HIT-HY 200 + HIT-Z

HIT-HY 200 + HIT-Z-R3/4

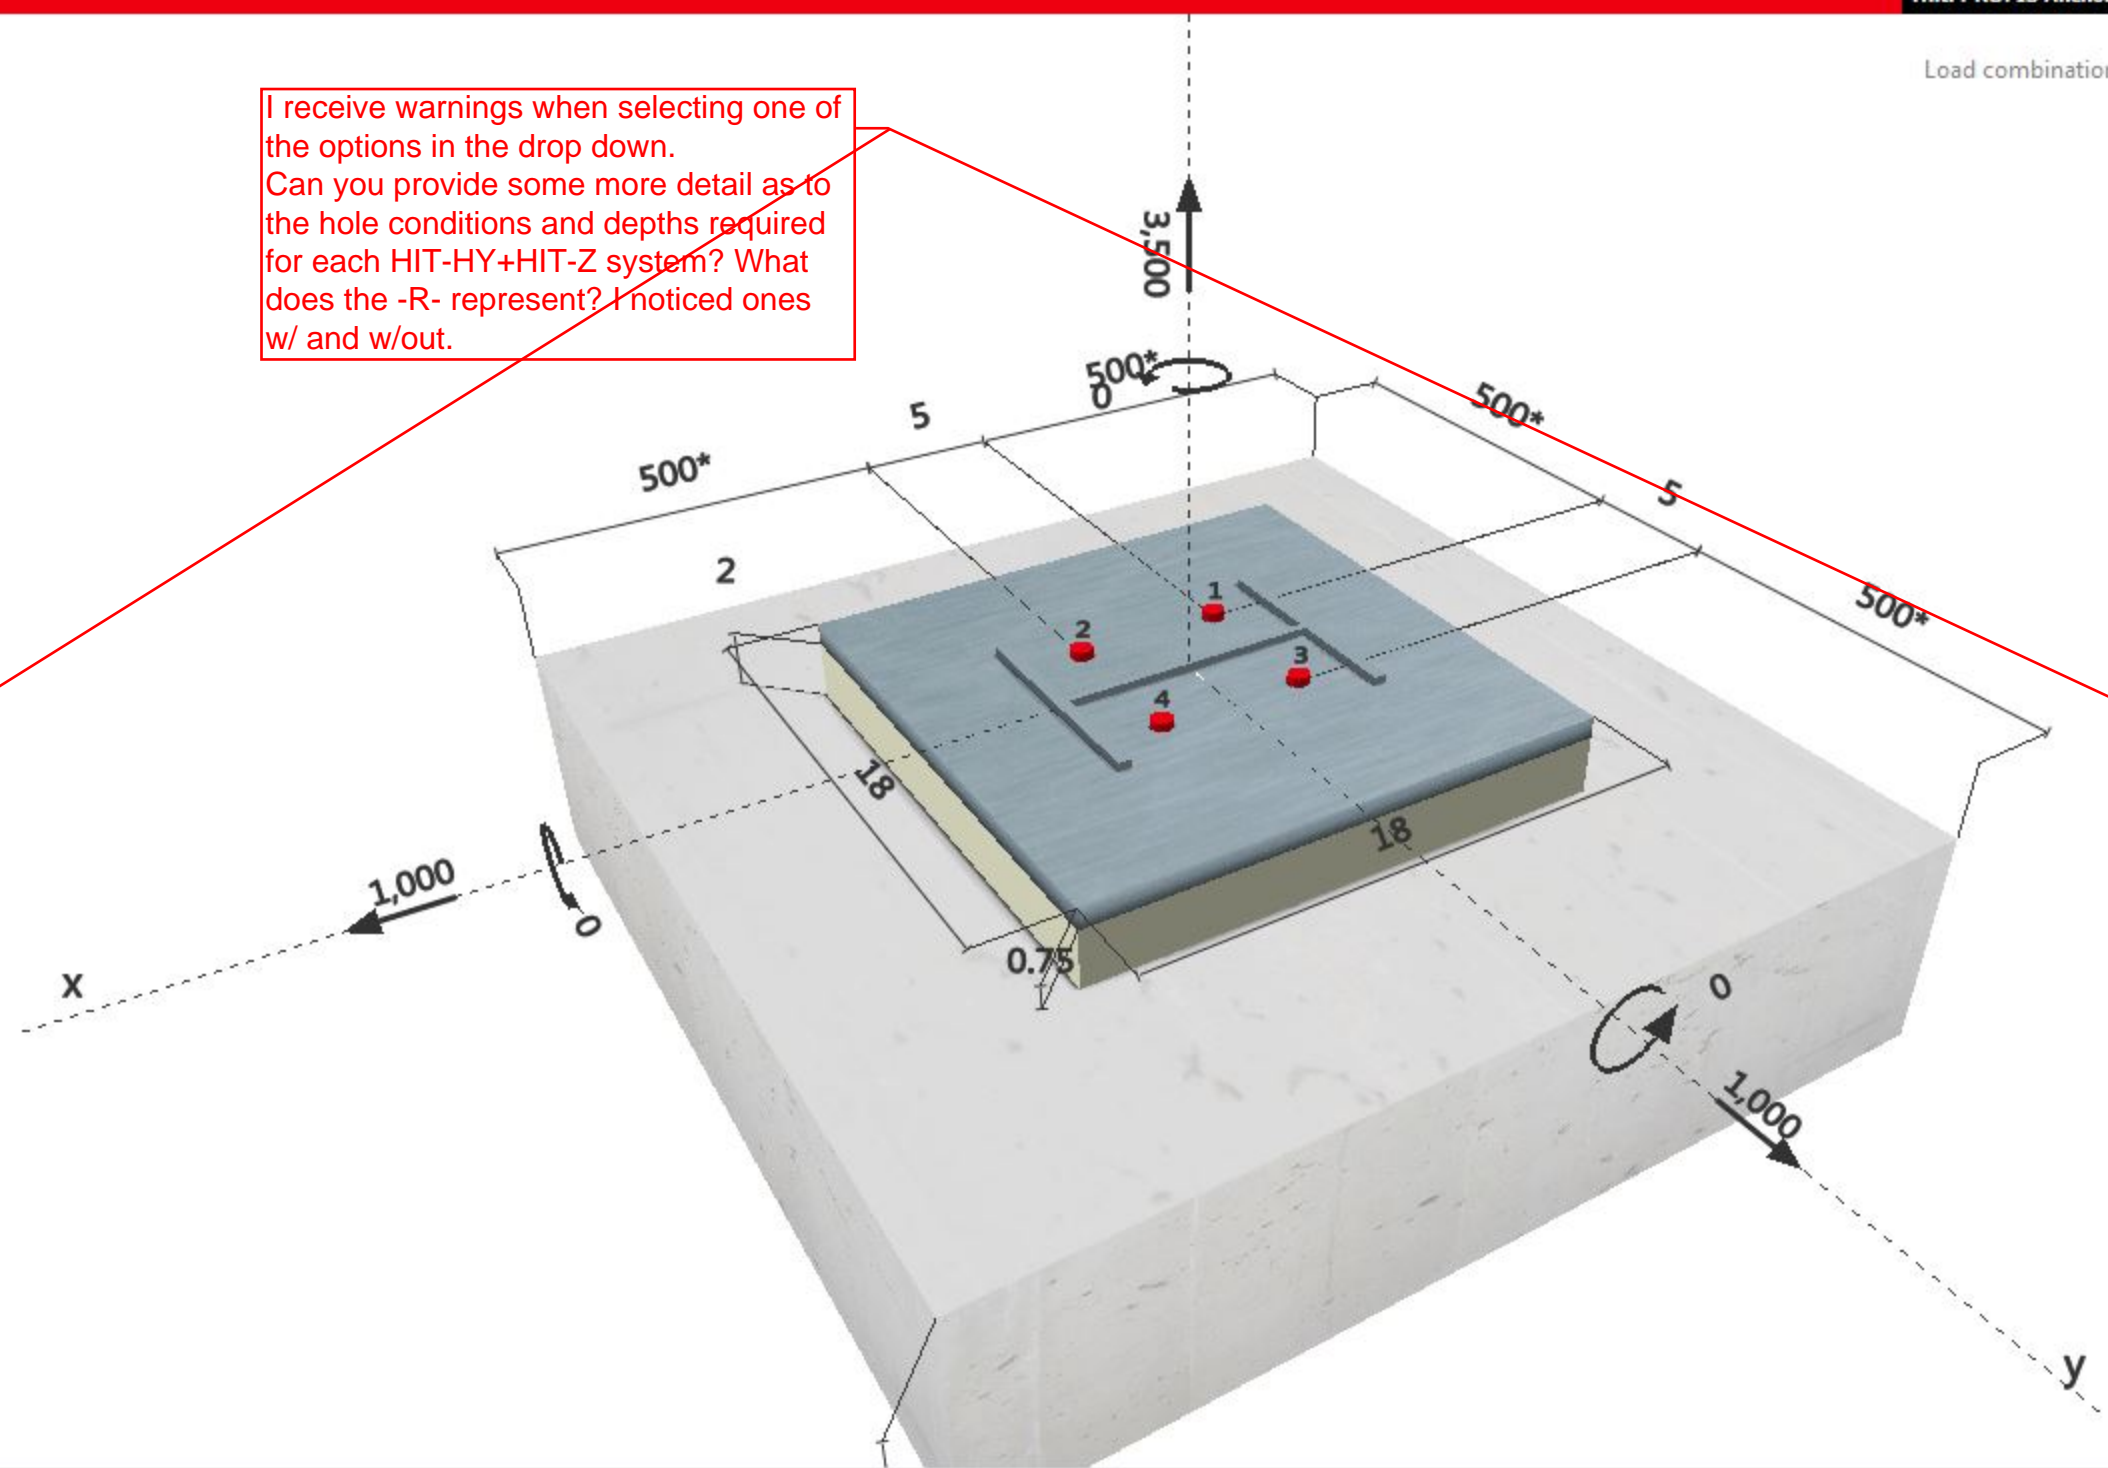
I receive warnings when selecting one of the options in the drop down. Can you provide some more detail as to the hole conditions and depths required for each HIT-HY+HIT-Z system? What does the -R- represent? I noticed ones w/ and w/out.

- See the Specification Text icon in the Solutions tab.
- Installation (hole condition) and drilling are not approved together.
- Concrete depth is insufficient for the current anchor (min = 10 in)!
